STAFF RECOMMENDATION
2119 Westwood Avenue
July 20, 2016

Application: New construction – addition and outbuilding; Setback Determination
District: Hillsboro-West End Neighborhood Conservation Zoning Overlay
Council District: 18
Map and Parcel Number: 10415040000
Applicant: Preston Quirk, Architect
Project Lead: Sean Alexander, sean.alexander@nashville.gov

SITE PLAN

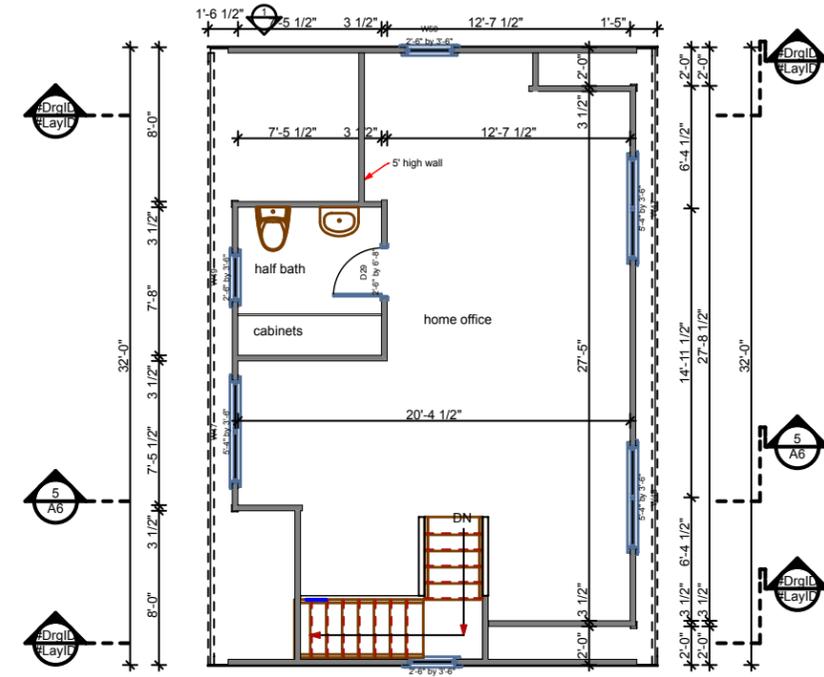
The new outbuilding does require a rear setback determination. Bulk zoning would require a twenty foot (20') rear setback and five foot (5') side setbacks. Staff finds that the proposed setbacks of ten feet (10') for the rear and three feet (3') for the left side are more typical of outbuildings historically than the bulk zoning would require.

ELEVATIONS - SIDES

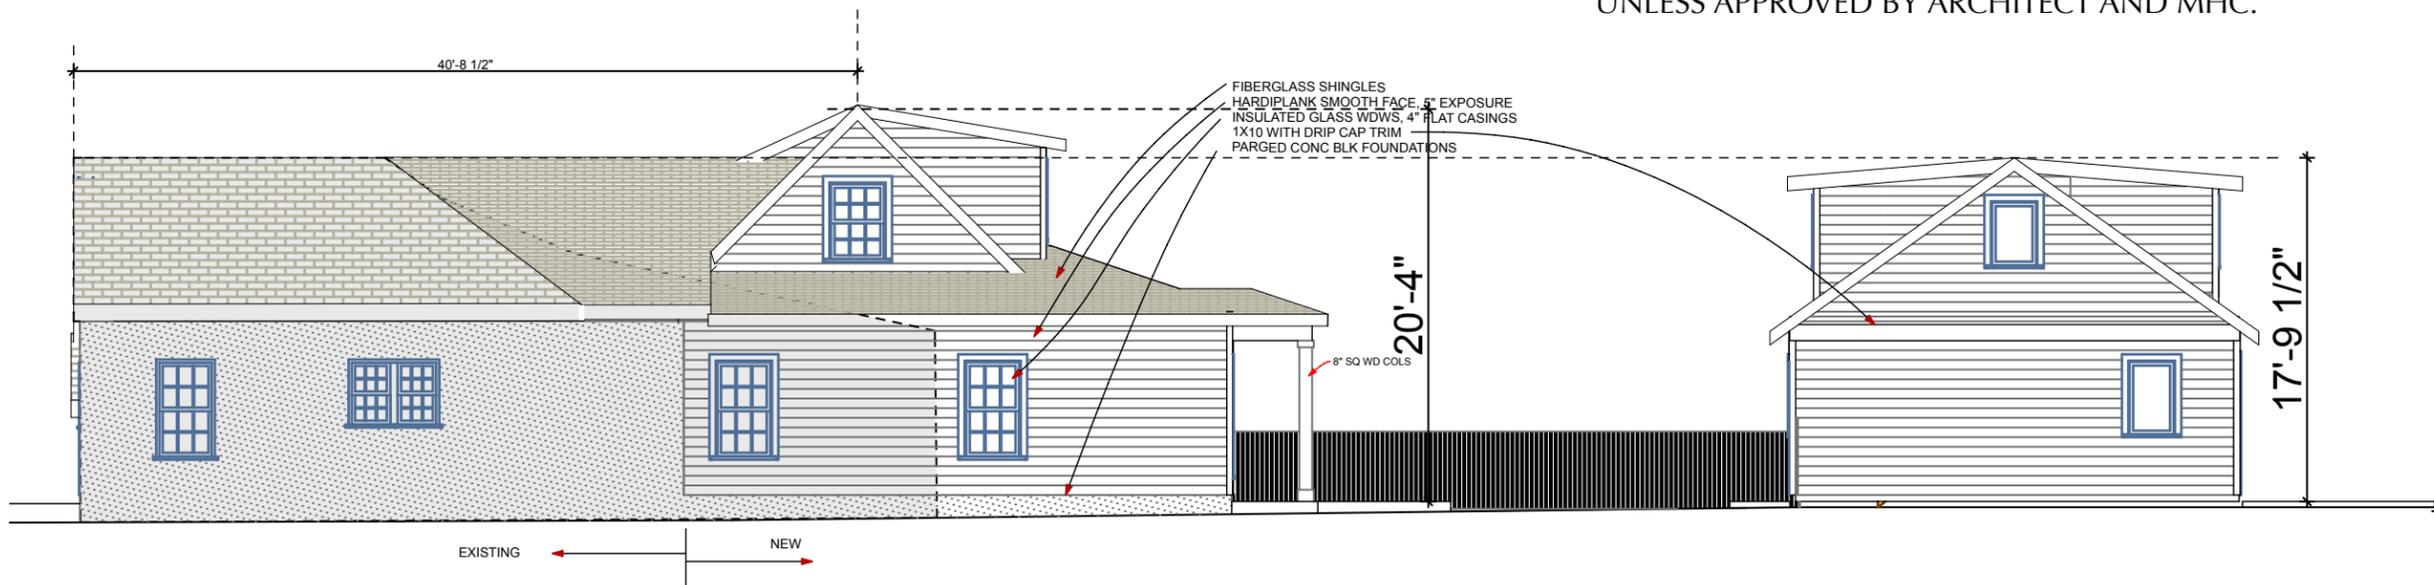
The addition will have a partial upperstory within the roof of a side-oriented gable. The second story gable-field walls will sit in from the primary first story side walls by four feet (4') on the left side, stacking over the existing rear addition, and the right side will be stepped in seven feet (7') from the first story wall. The addition will not impact the front or sides of the original building and will not extend beyond the side planes of the original house or its roof. The side-gable component will also have a shed-roofed dormer on the rear with the sides stepped in an additional two feet (2'). The ridge of the side-gabled roof of the addition will be three feet (3') taller than the original roof, but because it is

Height & Scale: The scale of the addition, although taller by three feet (3'), will be subordinate to that of the historic house because the sides are sufficiently stepped in so as to screen it behind the original roof. The primary eave of the addition will tie into the eaves of the existing addition, which sits below the original eaves at the rear of the house. The additional height is more than forty feet (40') back from the front of the house, which meets the guidelines for when additions need to be taller. Staff finds the project meets sections II.B.1.a and II.B.1.b of the design guidelines

GARAGE ELEVATIONS

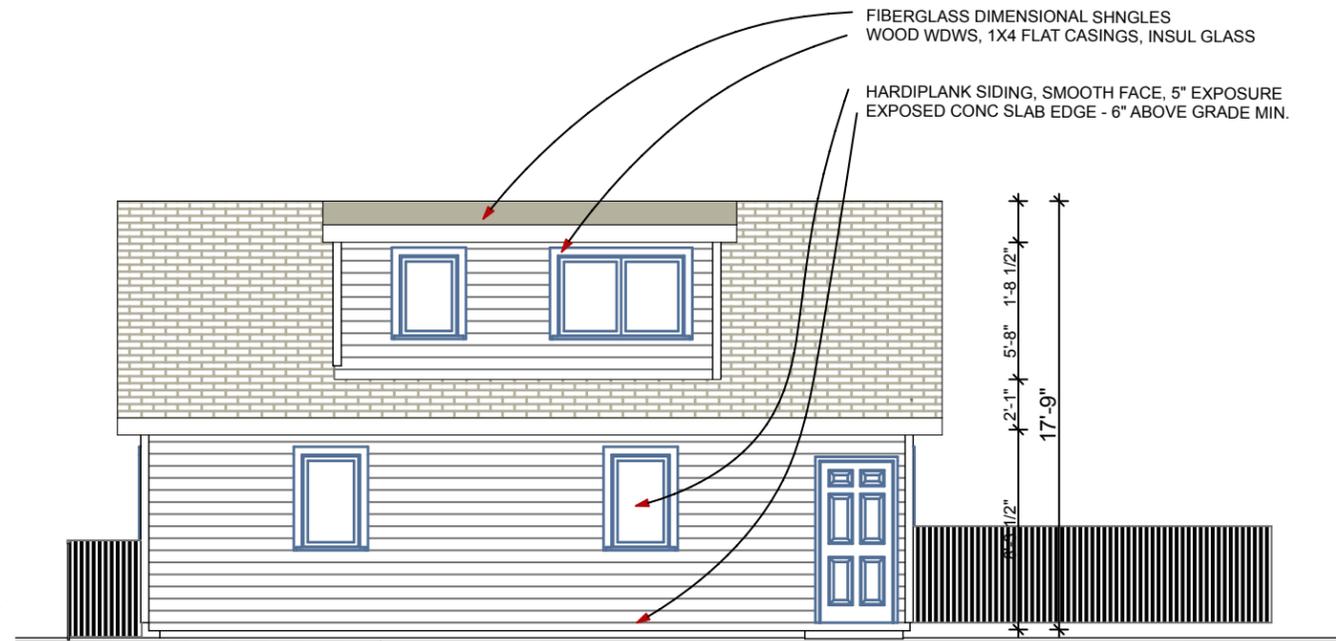
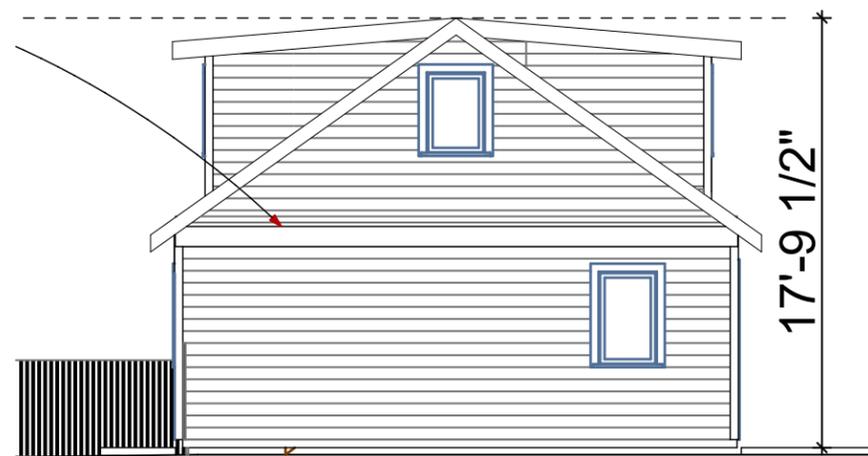
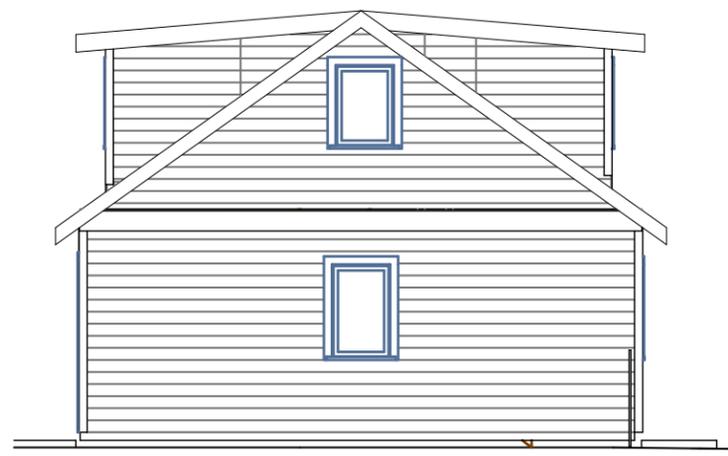
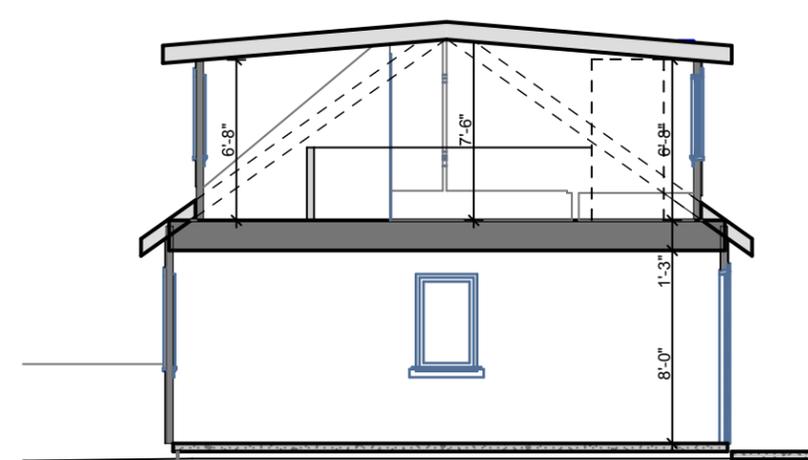
Outbuilding: The project also includes a new outbuilding at the rear of the lot. The outbuilding will not be used as a detached accessory dwelling unit. The outbuilding will have a seven-hundred, forty-five square foot (745 sf) footprint, with a roof height matching the roof of the historic house at twenty feet (20') tall and an eave height of nine feet (9'). The materials of the proposed outbuilding will match those of the new addition, including cement-fiber siding with a five inch (5") exposure, an asphalt single roof, and a concrete slab foundation. The windows and doors have not been determined, and staff asks to approve the final window and door selections prior to purchase and installation. With the staff's final approval of the windows and doors, staff finds the known materials to be appropriate for outbuildings.

The roof of the outbuilding will be a side-oriented gable with a pitch of 9:12. Both slopes of the building's roof will have shed-roofed dormers with a nearly-flat 1:12 pitch. The front dormer will be half the width of the first story roof and the sides of the rear dormer will be stepped in two feet (2') from the primary walls of the building. Staff finds these roofs to be compatible with those of the historic house.
